UNITED STATES PATENT AND TRADEMARK OFFICE

APPLICATION NO.	FILING DATE	FIRST NAMED INVENTOR	ATTORNEY DOCKET NO.	CONFIRMATION NO.
10/777,496	02/12/2004	Christopher Charles Andrews	327723	5259
43074 7590 12/29/2008 FAEGRE & BENSON, LLP 32469 2200 WELLS FARGO CENTER 90 SOUTH SEVENTH STREET MINNEAPOLIS, MN 55402-3901				
EXAMINER				
LANG, AMY T				
ART UNIT		PAPER NUMBER		
3731				
NOTIFICATION DATE		DELIVERY MODE		
12/29/2008		ELECTRONIC

Office Action Summary

DETAILED ACTION

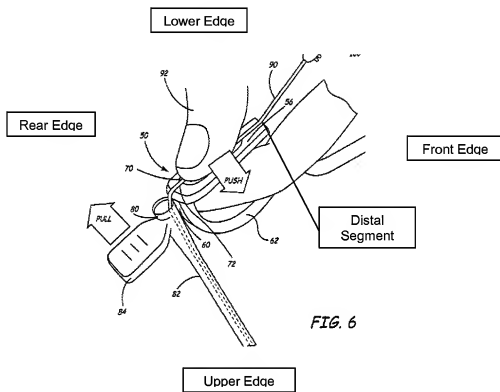
With regard to **claims 1 and 9**, Gardeski et al. (hereinafter Gardeski) discloses a device for removing a guide catheter from a linear lead (see entire document). The device comprises a body (62) having a front, rear, upper, and lower edge. The edge sides are all relative placement terms such that the upward side, as shown in the figures, can be deemed a lower edge. Furthermore, the device is configured for use in an upward down placement which would cause the lower and upper edge to be as such shown below.

As shown in Figure 4 and below, Gardeski discloses a distal lead management segment (51) having an outer surface and comprising a side opening member, the rear or front opening ([0050]). The lumen through the side opening (72) overlaps the instantly claimed central opening since it is sized to engage the linear lead. The distal lead management segment is adjacent the lower edge and positioned between the front and rear edges of the body. Additionally, the device of Gardeski only secures the linear

FIG. 3 70

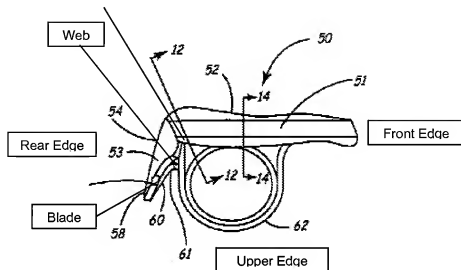
A blade (60) is mounted on the distal lead management segment (51) and connected to the body (62) by a connecting segment located between the lower edge and the distal segment (column 7, line 61 through column 8, line 10). As shown in Figure 3 and below, the distal lead management segment comprises a rear portion (53) that extends distal of the blade and overlaps the instantly claimed outer surface. Therefore, the blade is then mounted between the lower edge and this outer surface.

Upper Portion of
Web

Lower Edge

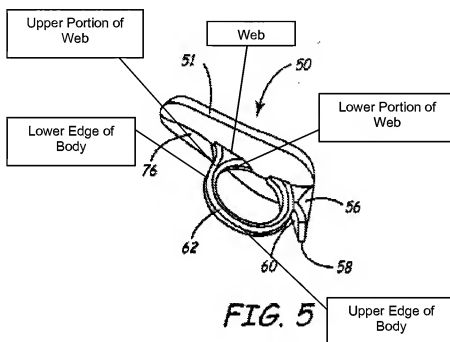
With regard to (i) above, it is the examiner's position that it would have been obvious at the time of the invention to one ordinary skill in the art for the connecting segment to comprise several cavities. This would advantageously reduce the weight of the device which allows for easier manipulation. Therefore, the connecting segment of Gardeski comprising several cavities would clearly overlap the instantly claimed web.

As shown above, the web of Gardeski connects to the lower edge of the device and includes an upper portion and a lower portion. The upper portion connects to the lower edge of the body. Additionally, the distal lead management segment is connected directly to the lower portion of the web.

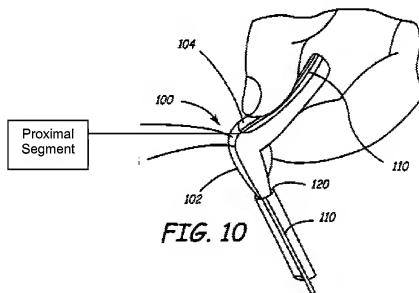
With regard to **claim 2**, since the cutting blade (60) is positioned close to the distal lead management segment and comprises the notch, it is the examiner's position that the notch is proximate the distal segment (Figure 3).
